Raymond S. Liatt, PE
5/7/96
LIGO D961175-00-V

PROCESS SYSTEMS INTERNATIONAL INC. 20 WALKUP DR. WESTBOROUGH, MASSACHUSETTS 01581 USA			
PIPING ARRANGEMENT ELEVATIONS CORNER STATION WASHINGTON L2G0 VACUUM EQUIPMENT			
CAD FILE	SIZE	ENG. NO.	REV.
V0495013/501352	D	V049-5-013	0
SCALE 3/8"=1'-0"	SHEET		2 OF 2

ELEVATION P
V049-5-012, SHT.4

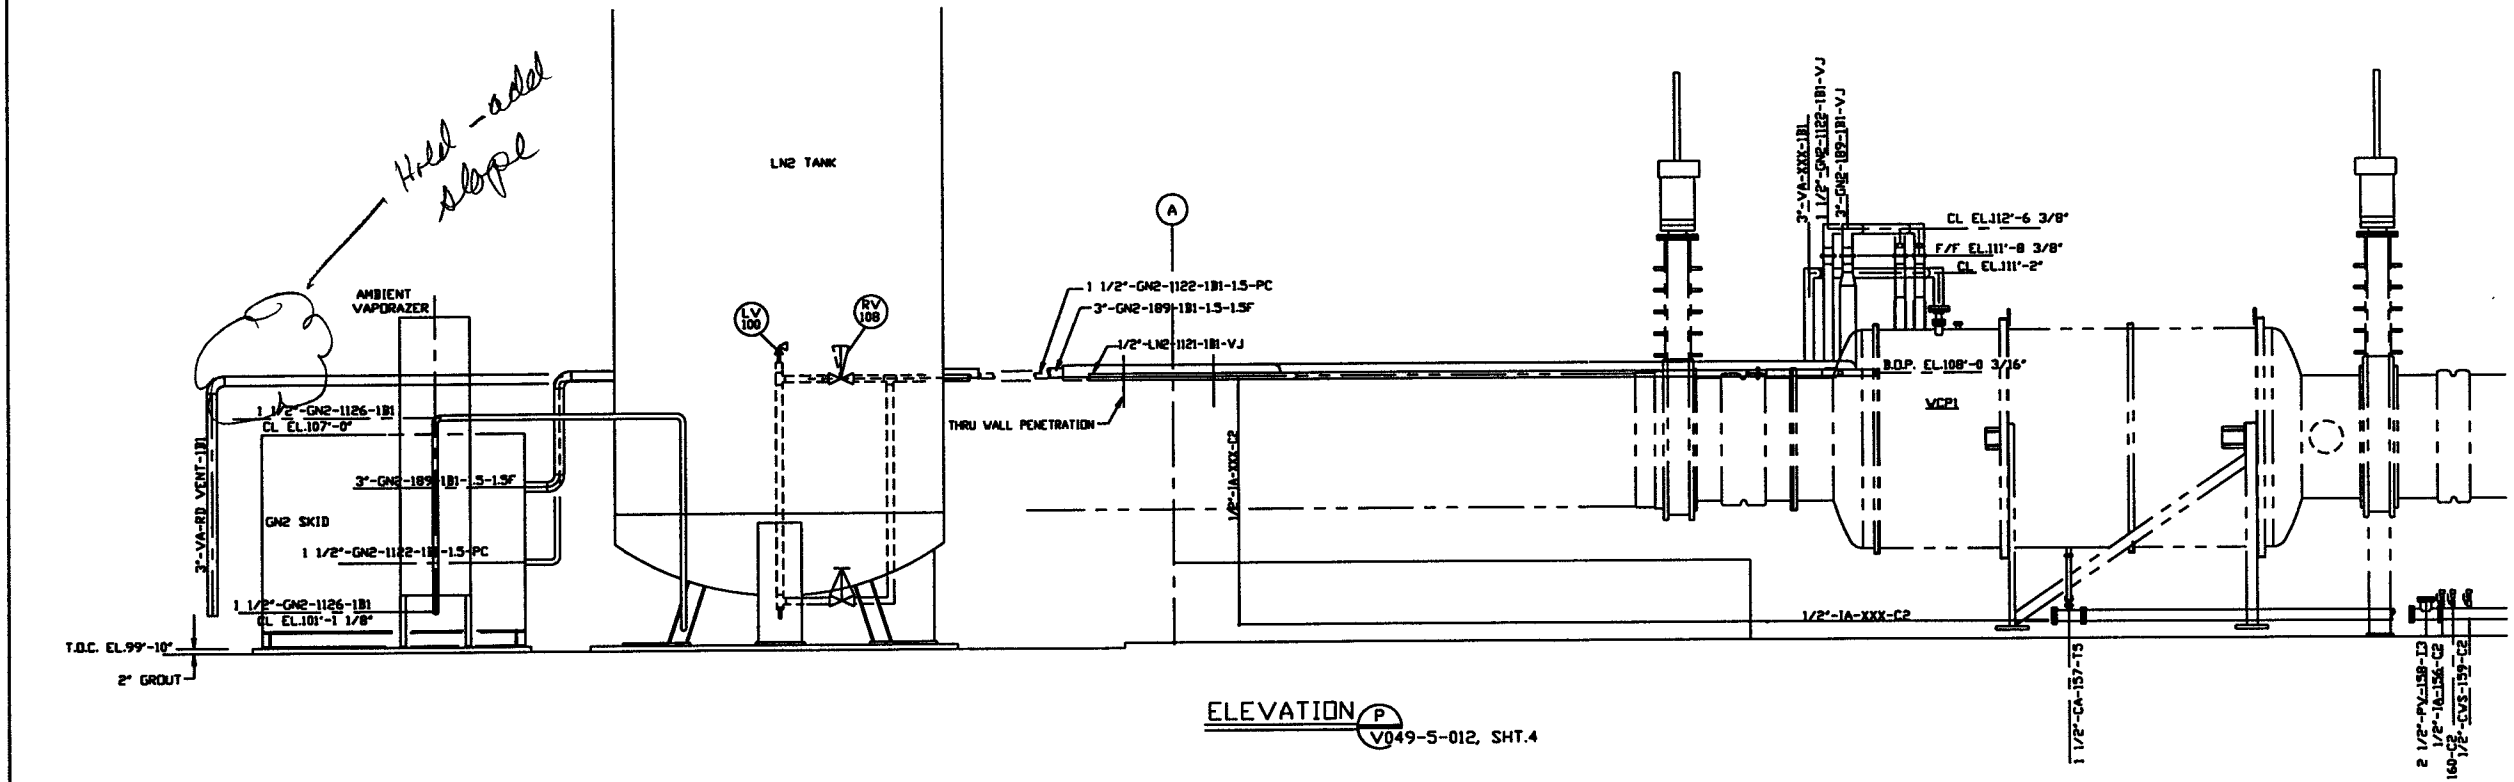
hold - add slope

Hold - add slope
